Notice of Intent

Sundry ID: 2838096

Type of Action: APD Change

WELL NAME	API Number
JRU Apache Federal Com 111H	30-015-56010
JRU Apache Federal Com 801H	30-015-56011
JRU Apache Federal Com 901H	30-015-55834
JRU Apache U Federal Com 704H	30-015-56188
JRU Apache Federal Com 705H	30-015-56229

Previous Design: 4-String Design – Engineered Weak Point**[Figure F] 4 String – 2nd Intermediate casing engineered weak point**

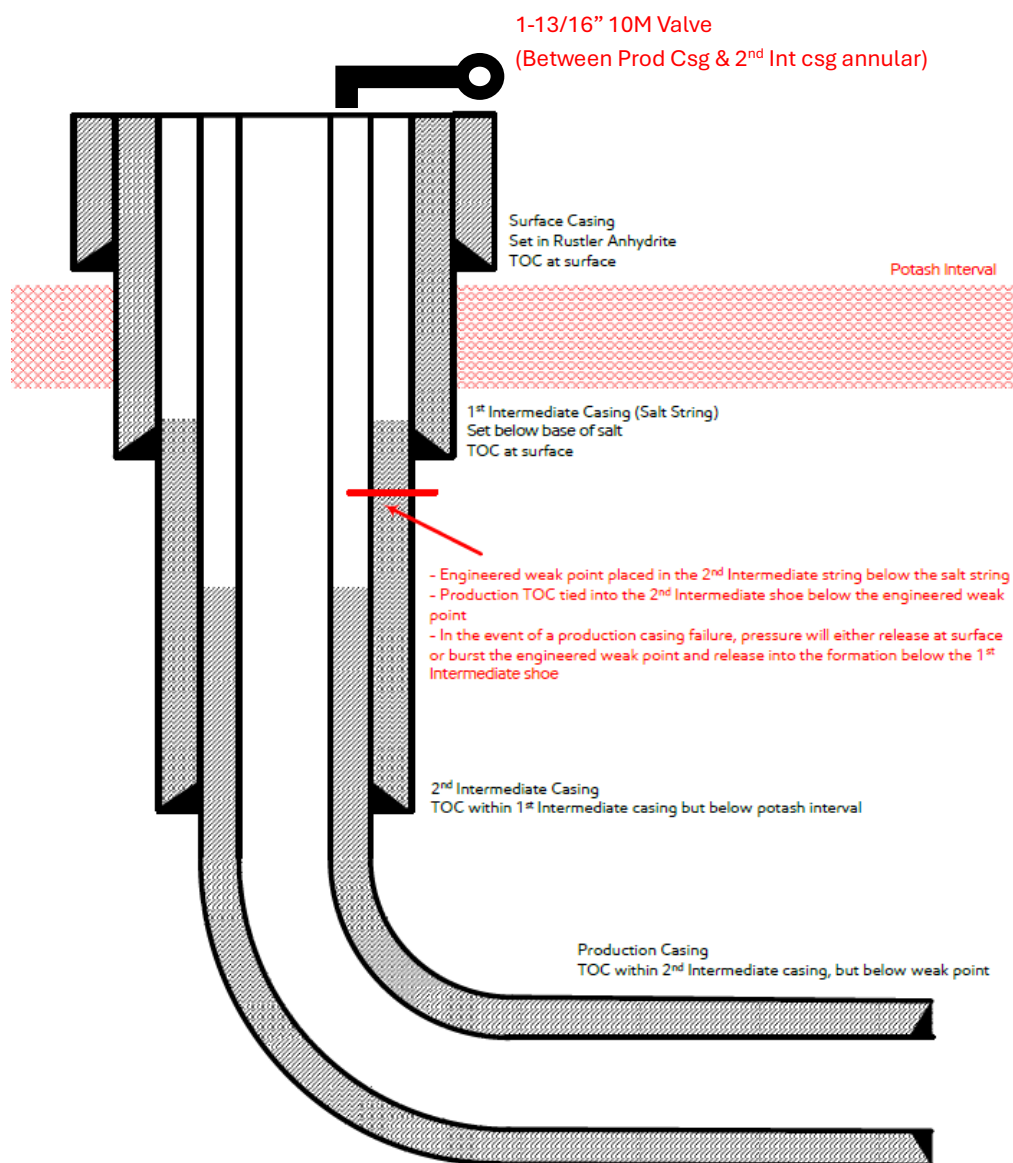
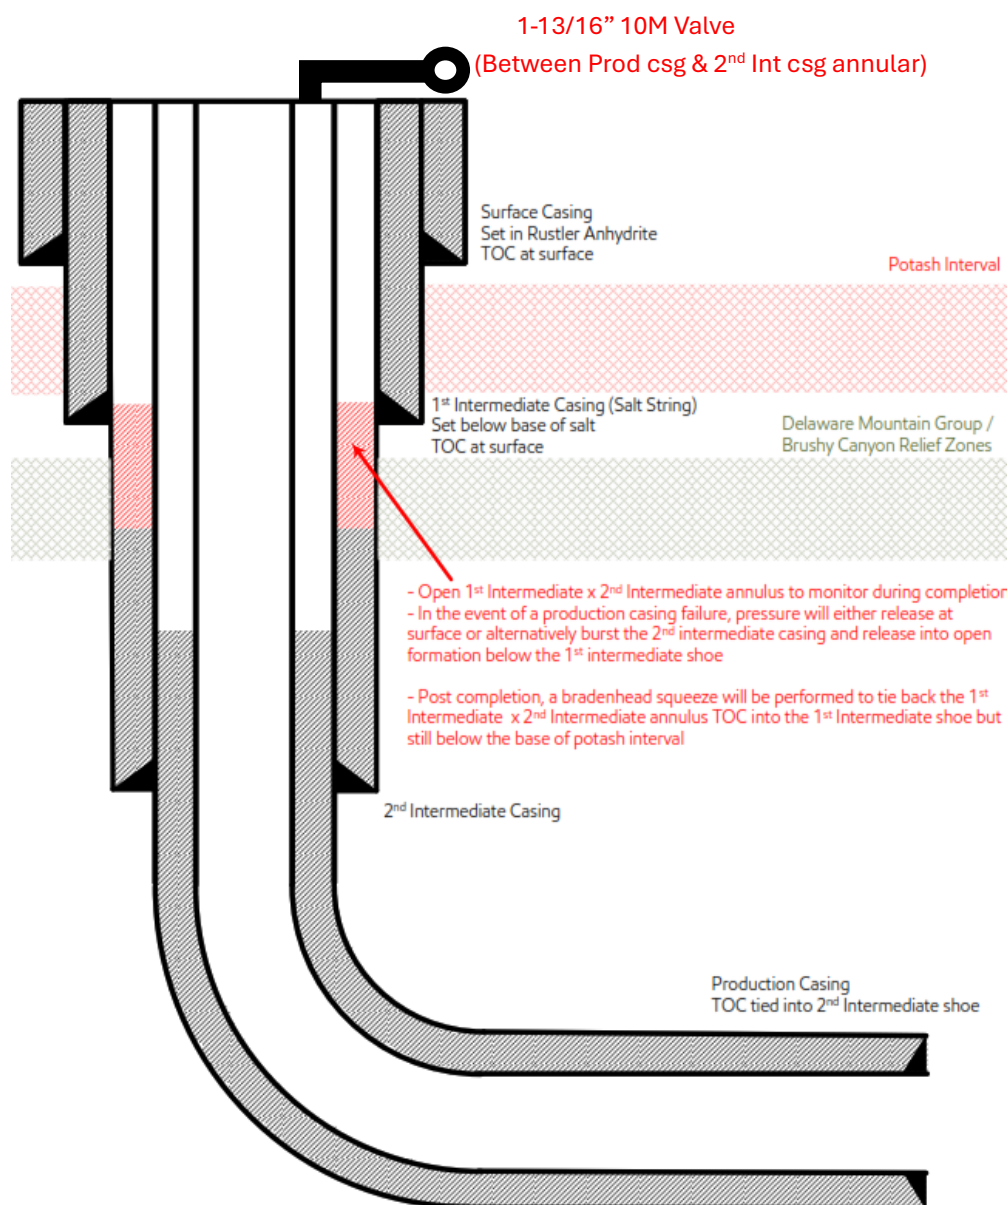
1. Casing design to be changed from the "4-String Design – Engineered Weak Point" (FIGURE F) to the "4-String Design – Open 1st INT x 2nd INT Annulus" (FIGURE D). An open annulus will be utilized and monitored during completions operations.

Post completion, bradenhead squeeze will be performed to tie back the 1st intermediate x 2nd intermediate annulus. TOC will be placed into the 1st intermediate shoe but still below the base of Potash interval.

2. No changes to the cementing, casing or mud circulating system designs will be required for the requested change.

New Proposed Design: 4 – String Design – Open 1st Int X 2nd Int Annulus (ICP 2 below relief zone)**[Figure D] 4 String – Uncemented annulus between 1st and 2nd intermediate casing strings**

- 1) Alignment with KPLA requirements per schematic above, leaving open annulus open for pressure monitoring during frac and utilizing new casing that meets API standards.
- 2) Contingency plans in place to divert fluids away from salt interval in event of production casing failure.
- 3) Intermediate 2 bradenhead squeeze to be completed within 180 days to tieback TOC to salt string at least 500ft but with top below Marker Bed 126.
- 4) Production cement to be tied back no less than 500ft inside previous casing shoe.
